TOWN OF LUNENBURG
PLANNING ADVISORY COMMITTEE
MEETING AGENDA

Subject: PAC - Rezoning of PIDs 60703881 & 60703899, Brook St.
From: Community Development
Date: July 7, 2024

- Staff have reviewed plans and materials provided by the applicant regarding servicing, parking & access, traffic, and electrical demand.
- The application is for a rezoning to allow for a 6-storey, 65-unit residential building at the corner of Falkland and Brook Streets.

Figure 3- Applicant plan showing parking spaces.

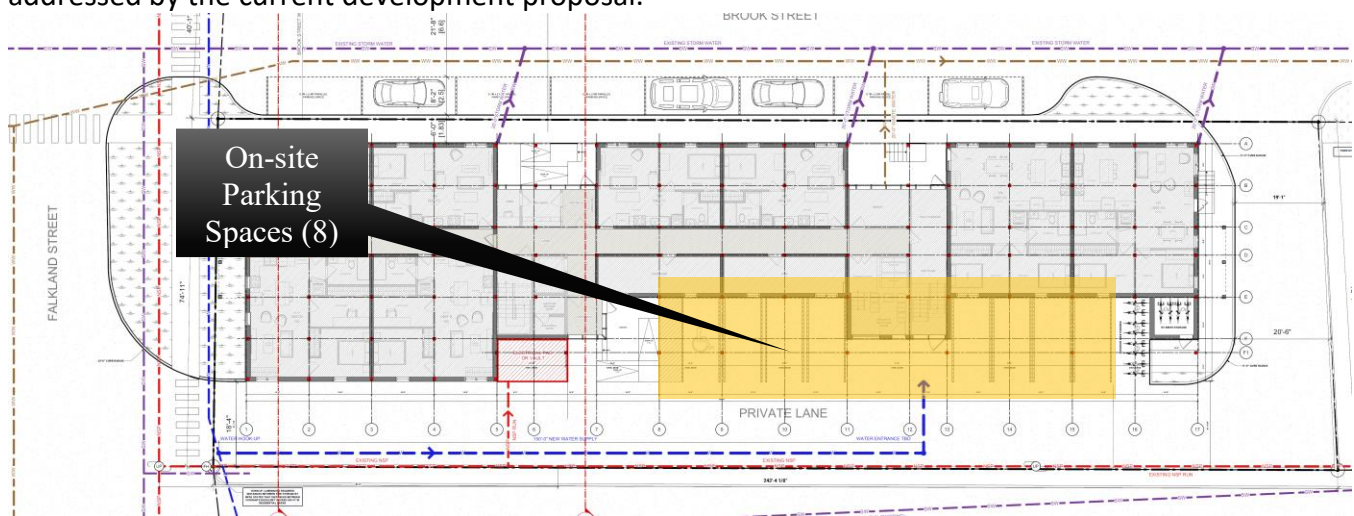
- Staff note that while 16 spaces are shown, only eight (8) on-site parking spaces are proposed for the 65 units in the building with the remainder to be accommodated by public street parking spaces.

- There is no provision for mandatory on-site parking in the MPS and LUB, however, Staff note the minimal onsite parking provision for the development.

- The understood intent for the remainder of the development's parking needs is envisioned to be absorbed by the surrounding public street areas, which will increase parking congestion in the area.

- This may implicate evaluation criteria 6-19 (c) (ix) on traffic and parking congestion, that is: *Council shall not amend the Land Use By-law or enter into a development agreement unless Council is satisfied the proposal does not allow: the creation of excessive traffic hazards or congestion on road, cycling, and pedestrian networks within, adjacent to, or leading to the proposal;*

- Staff feel additional rationale and detail on this facet of the development would be helpful to the evaluation. The application package contained a parking lot design, but did not provide details on how the number of parking spaces was determined. In addition, Staff note that the traffic analysis and other materials did not address this issue or its impact on public parking space utilization or demand.

As previously noted, the proposed conceptual development provides on-site parking; however, there are only eight parking spaces shown, one of which is accessible. This is a parking ratio of one parking space for every 8.1 dwelling units. Staff are concerned that the actual demand for parking may far exceed what has been shown in the development plans. The MPS makes it clear that the Town does not currently mandate minimum parking space requirements, but it does not state parking is not a requirement for development. This is an important distinction. Section 4.5.1 of the MPS states that “The development of new land uses necessitates travel between those uses.” The MPS goes on to state in Section 4.5.2, that “... residential developers have a strong incentive to provide adequate parking to meet the needs of their target market.” Staff are concerned that this need may not be adequately addressed by the current development proposal.
